From: DaSilva, Luis [REDACTED]
Sent: 26 April 2019 14:13
To: Planning.Responses
Subject: planning application consultation.- Y/22/19/PL

Your Ref
Y/22/19/PL
Our Ref
PLAN-027473
Date
26/04/2019

Proposal: Demolition of existing redundant garage building & erection of 1 No. dwelling and associated works (alternative following Y/68/17/PL). This application may affect the setting of listed buildings & may affect the character & appearance of the Main Road/Church Road, Yapton Conservation Area.
Site: Garage Premises, Main Road Yapton, BN18 0EA
Y/22/19/PL

Due to surface water inundation issues in the Lidsey Catchment "The applicant is advised to adopt, where appropriate, the measures in the table "Practical measures to reduce the potential impacts of development".

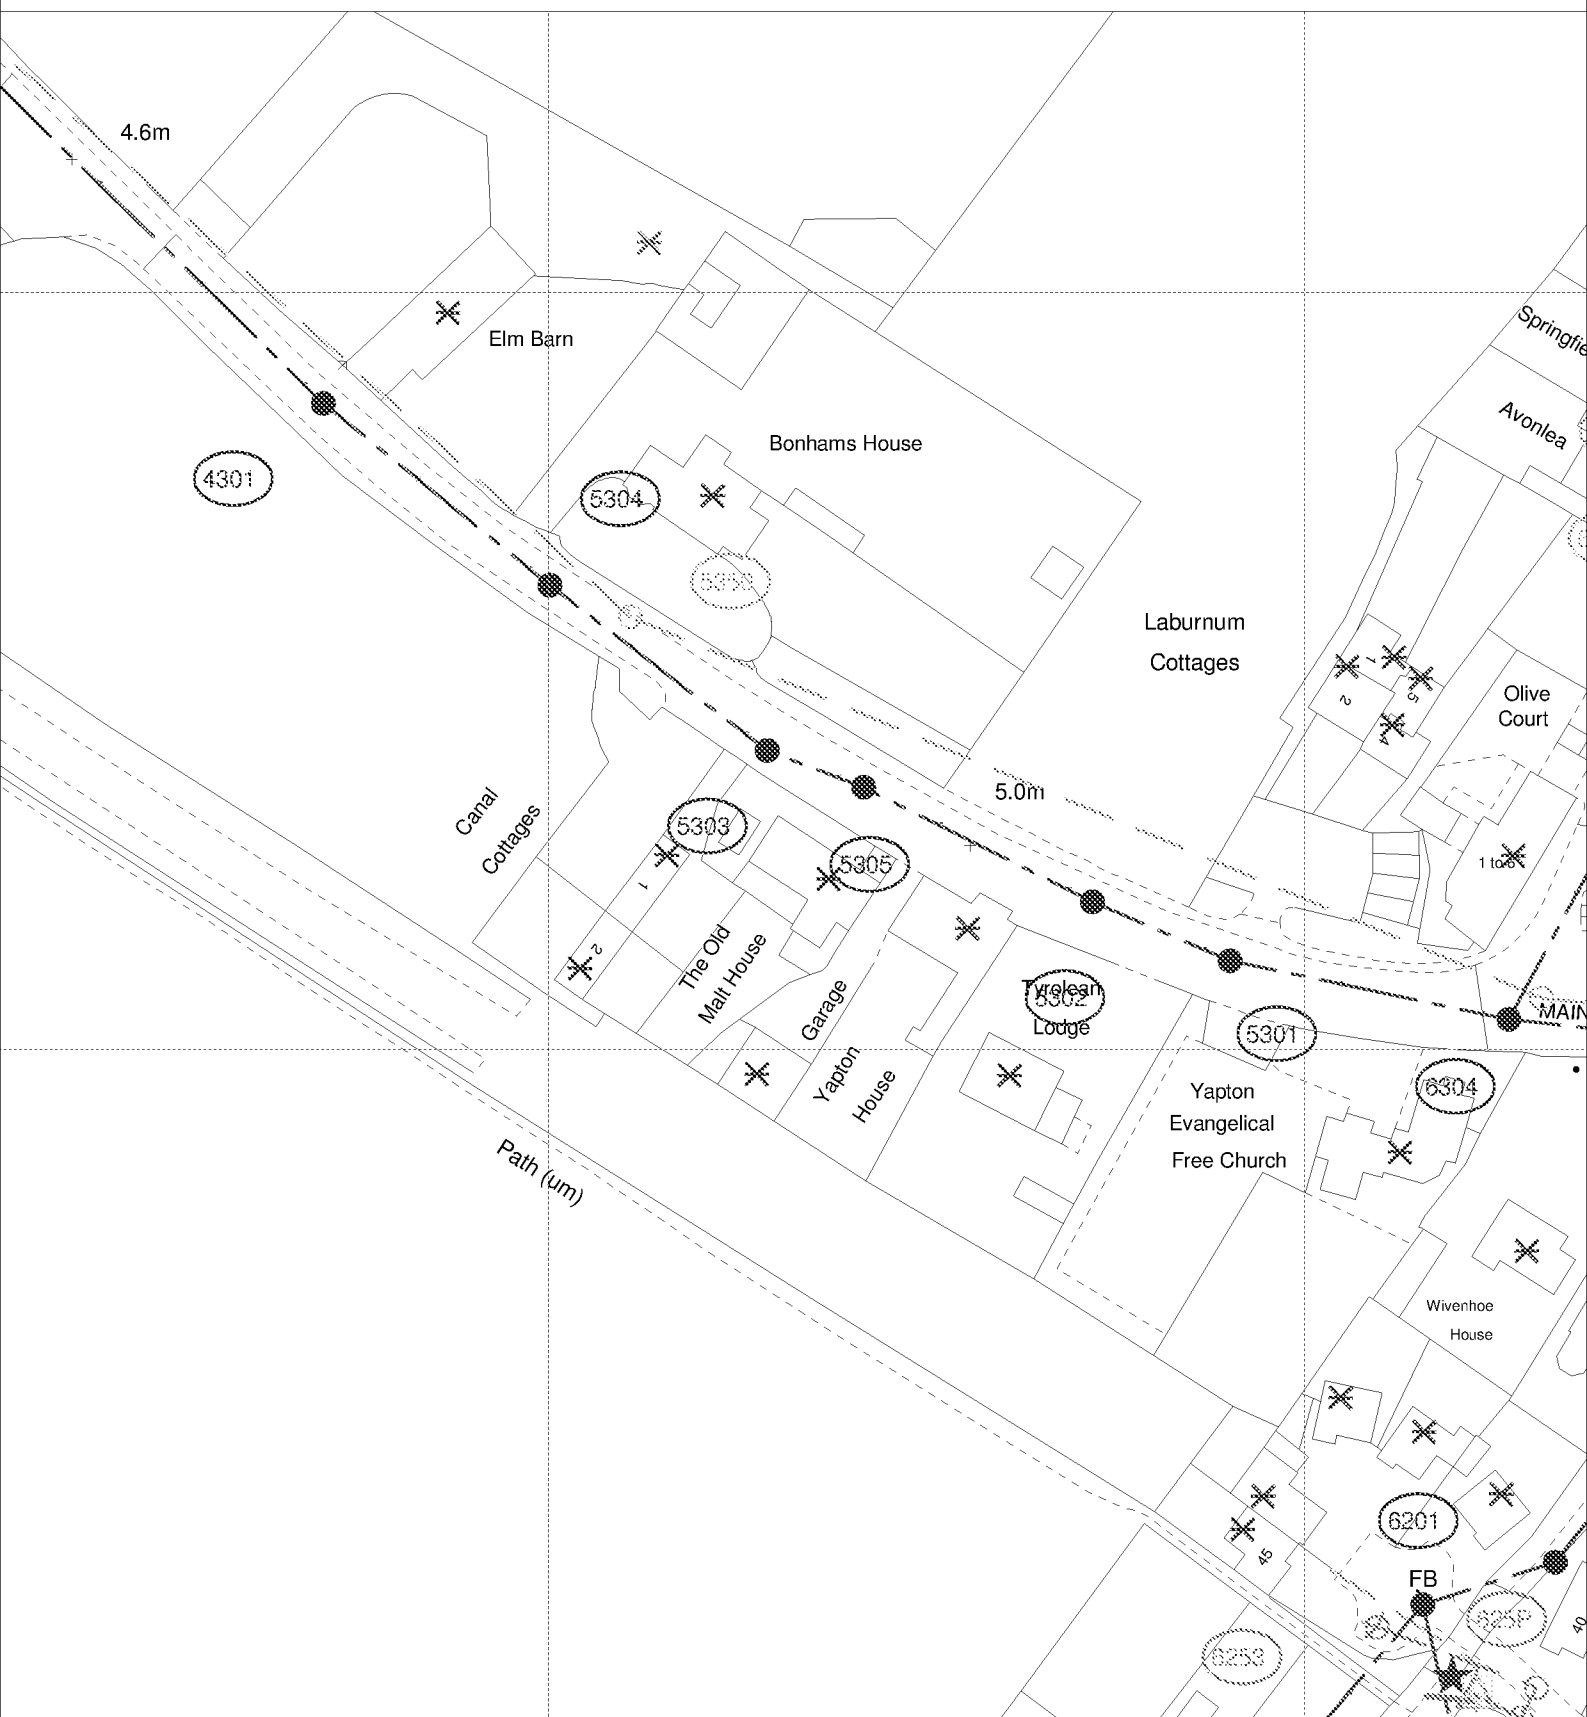
Developer should look to protect the public sewerage system from inundation and infiltration, which contribute to flooding in unfavourable conditions.
